Response to - 16/02662/PREAPP - Refurbishment of West Purifier House and Engine House (Grade II Listed) for residential use.

6th June 2016

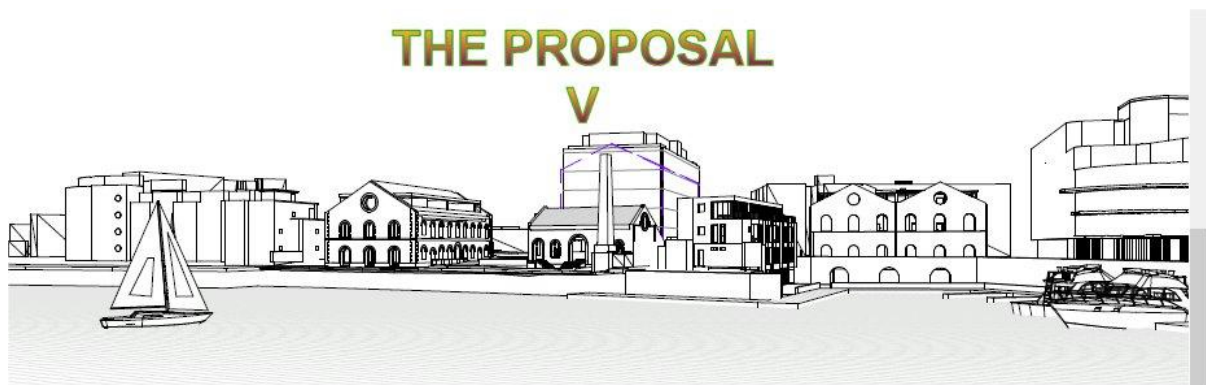
The Society suggests that when the design is developed it should include a pitched roof as was included in permission 11/03266/F. In this setting BCS21 requires high quality design, which implies a design informed by the dominant local architectural characteristics; the pitched roofs of the two Purifier Houses.
